[REDACTED]
Subject: 20251010 - S. 16 Planning Application No. A/YL-KTN/1160

有關對運輸署 A/YL-KTN/1160 的查詢

有關 A/YL-KTN/1160 的修改詳細

Proposed Temporary Place of Recreation, Sports or Culture (Hobby Farm) with Ancillary Facilities and Associated Filling of Land For a Period of 5 Years

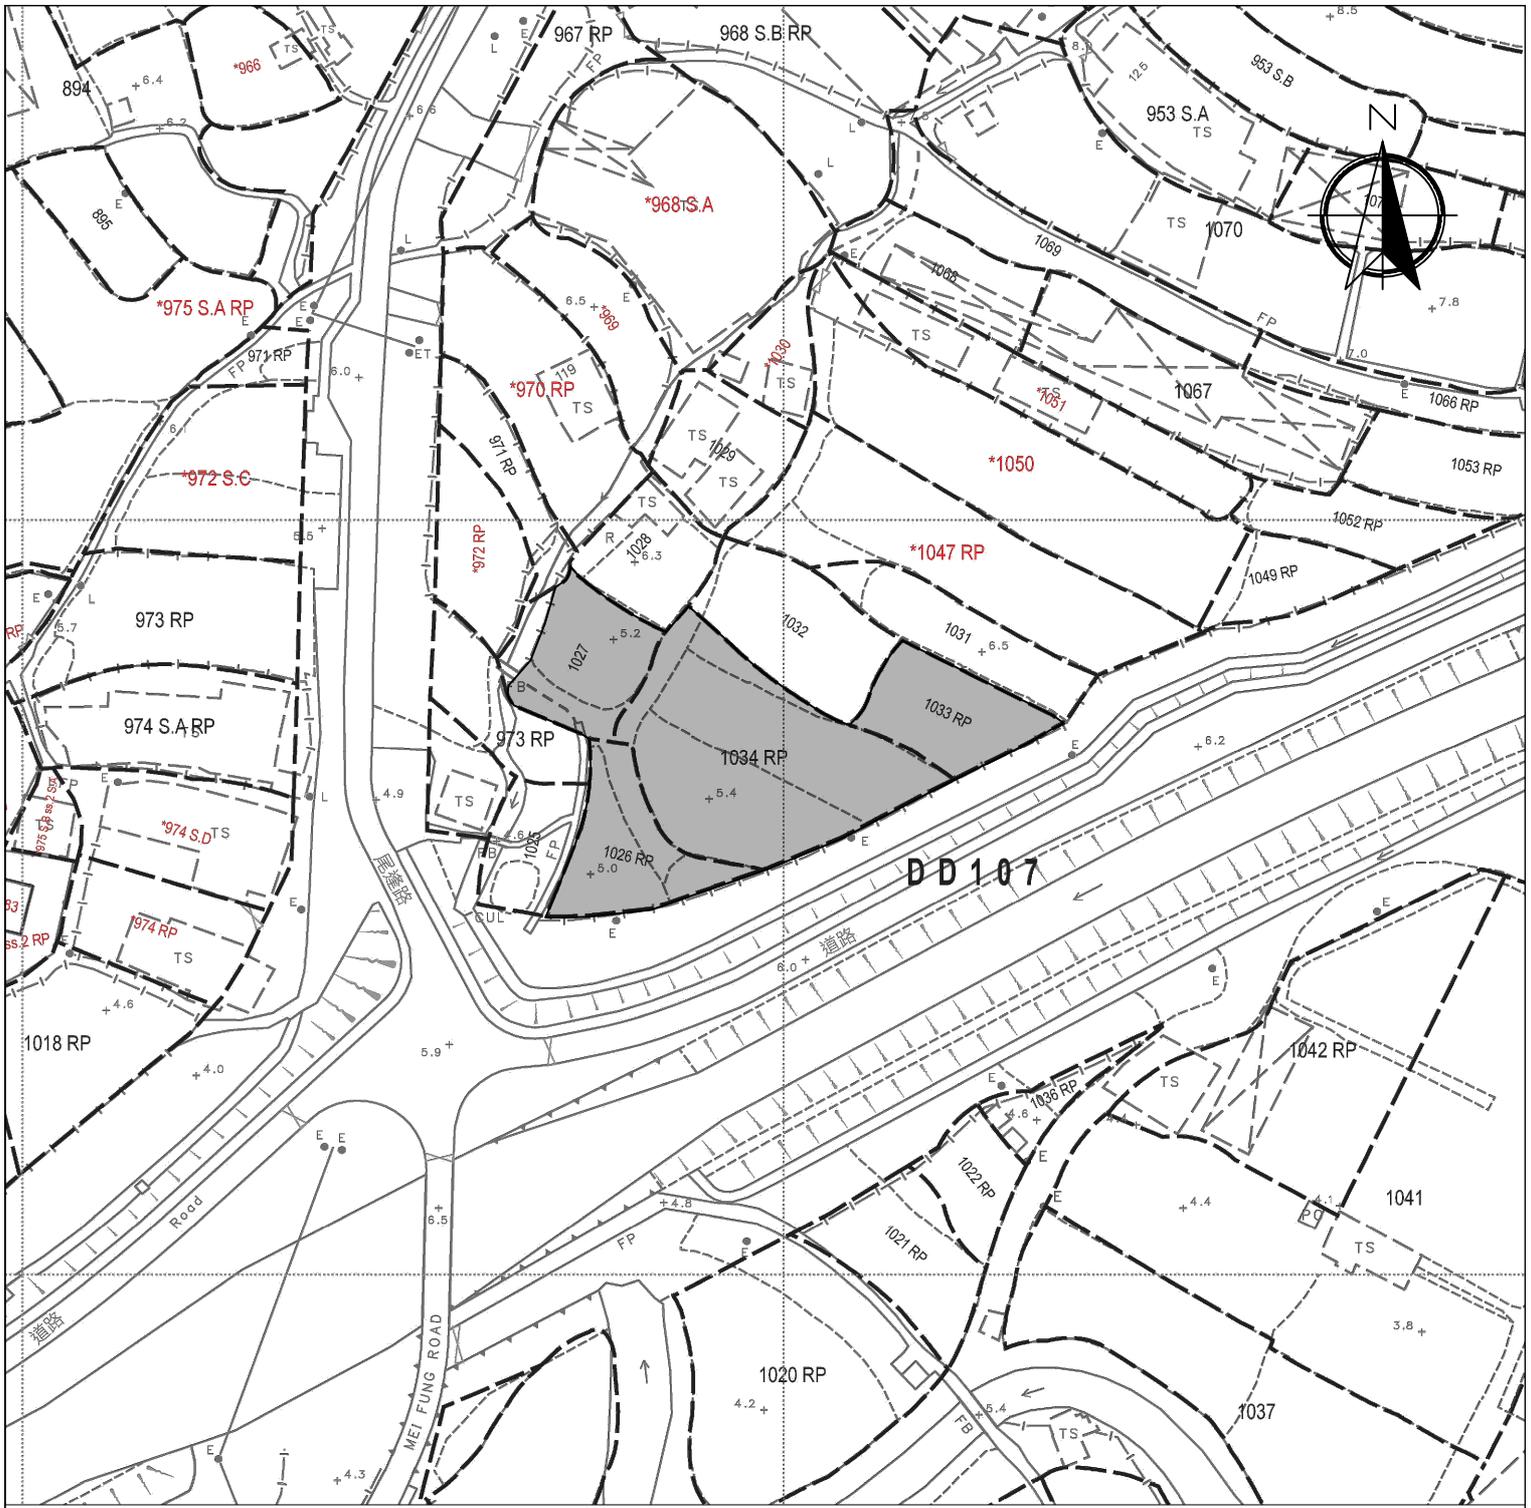
前往至本申請地點主要使用尾邊路，該道路為一條單線雙程的道路，並備有避車處。經修改後，申請地點範圍內不會提供任何停車位及上落位置。使用人士需以公共交通工具前往。

在尾邊路的路邊可上落物料及參與人士，該位置只會用作上落用途，不會長期停泊。由於只有少量人數及物料，相信不會影響該路的運作。以下為上落位置：

申請地點可以公共交通工具到達，線路為綠色專線小巴 620 號線路前往至申請地點約 600 米外的小巴士站，再以步行形式約 8 分鐘前往申請地點，小巴士站請參考下圖：

1-01

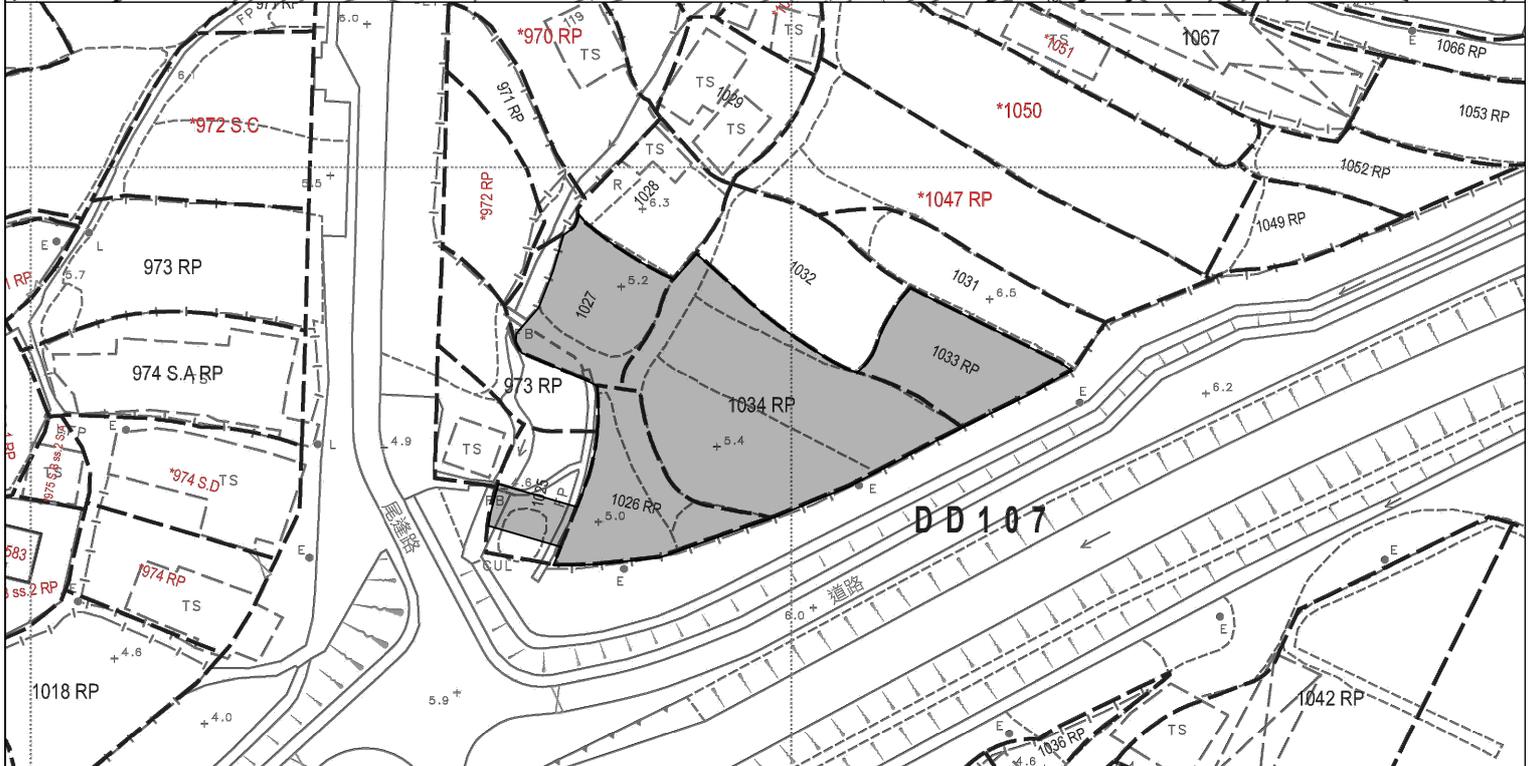
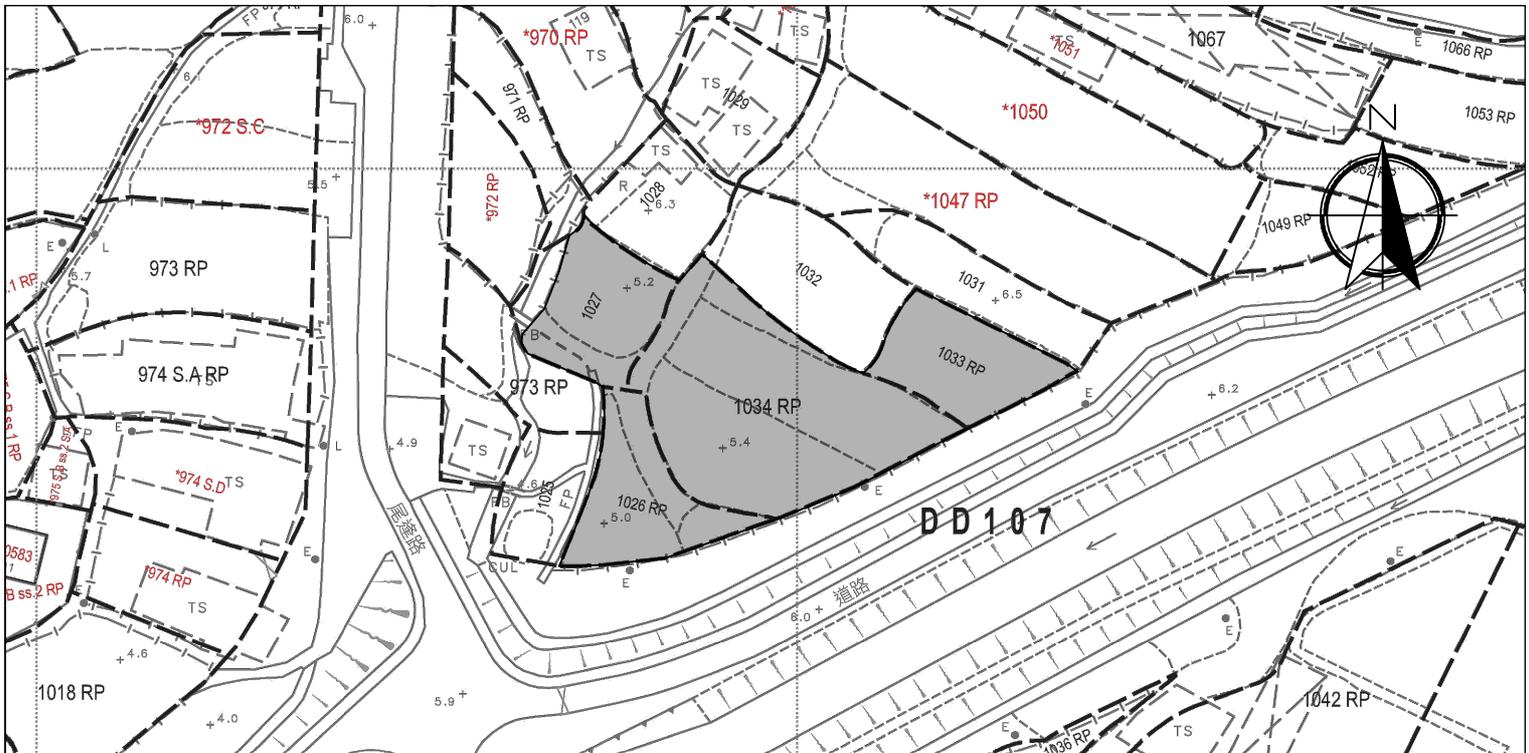
由於 D.D. 107 Lot 1025 有其他發展計劃，本申請會將該地段移出申請範圍，本申請不會包含該地段，但仍然會使用現有的行人通道經過該地段前往至本申請地點，並已獲得有關持分者的同意。

經修改後的申請面積由約 1,670 平方米減少至約 1,610.5 平方米，面積減少約 59.5 平方米或大約 3.6%總面積，詳細請參考本文件 Appendix 1。

Original Application Site Area: About 1,670 m²
 Site Area without Lot 1025: About 1,610.5 m²
 Difference between the 2 area: About 59.5 m² (About 3.6%)
